## **REMARKS**

**In the Drawings:**

Applicants are submitting proposed corrections for Figures 1-3. The present proposed amendment adds labels to the boxes and changes the reference characters so that they match the reference characters used in the description.

FIG. 1

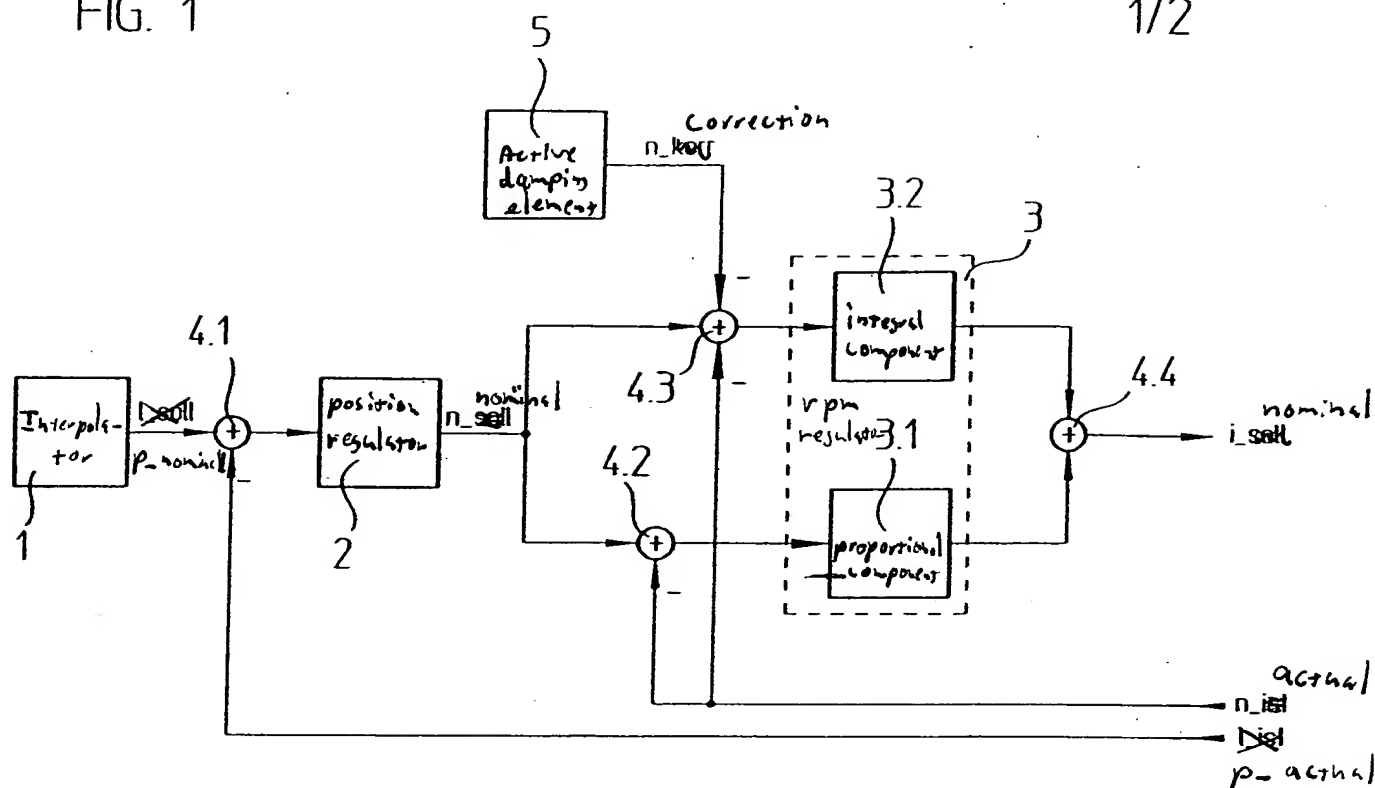
The additions have been indicated in red ink. Furthermore, it is not believed that the corrections involve new matter. Accordingly, please indicate whether the corrections are acceptable in the next Office Action.
